Design, Estimating, and Construction Review

Pojoaque Basin Regional Water System

Upper-Colorado Region, New Mexico

December 2009

Hybrid or Injection Wells

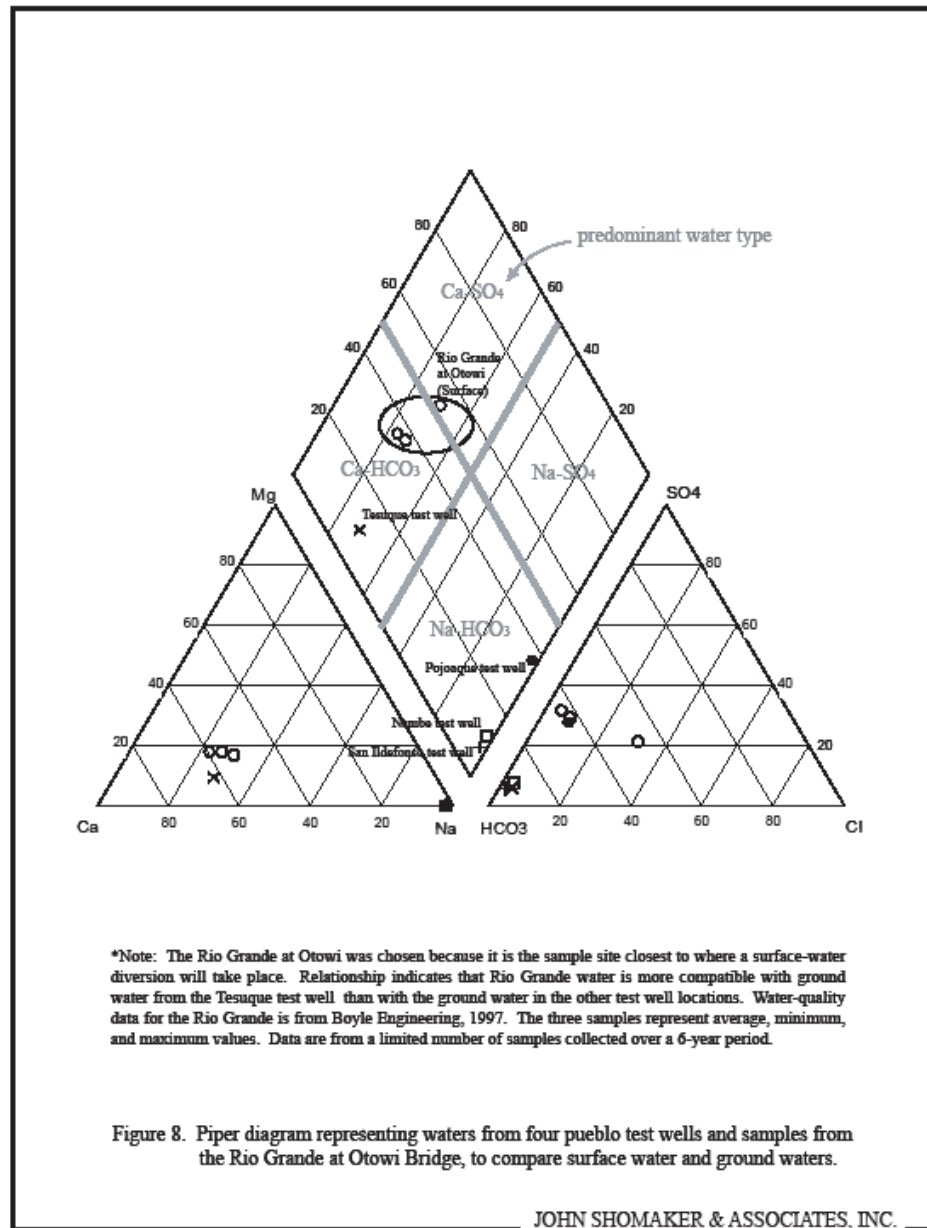
The design team has proposed to utilize hybrid wells to ensure that a redundant supplemental water supply is available. The Team recognizes the need to have a redundant water supply to supplement times when surface water is not available due to high turbidity or other factors that affect intake or water treatment. It is the understanding of the Team that these wells are to be developed as part of an aquifer storage and recovery (ASR) project. In the *Pojoaque Regional Water System Engineering Report*, (HKM Engineering 2008, p.37) the design team has presented the understanding that:

The proposal to inject treated water for recovery at a later date has yet to be determined as a viable solution. The Team was not able to find a study that verifies the injection process will solve the supplemental water issue. The Team has concern that injecting excess water from the surface water source may create more problems than it would solve. The following is an excerpt from the *Aamodt Settlement Study Report, Appendix 18, Final Report for Task 3 Deep Well / Well Field Investigation and Integration* prepared for Northern Pueblos Tributary Water Rights Association (Leder 2003, p. 26, 60, 61):

It is understood that the design team recognizes that considerable planning and design work is needed, and a final decision needs to be made regarding whether ASR injection wells are to be included in the overall project. It is the Team’s opinion that further investigation and study to prove the viability of this ASR project’s ability to provide a safe and verifiable water source is required before this plan can be applied to this project as a supplemental water supply.

The Team feels that until further investigation verifying ASR as a viable supplemental source of water for this project is available that it not be considered in a Feasibility level design, and that another verifiable supplemental water source be provided for in the cost estimate at this time.
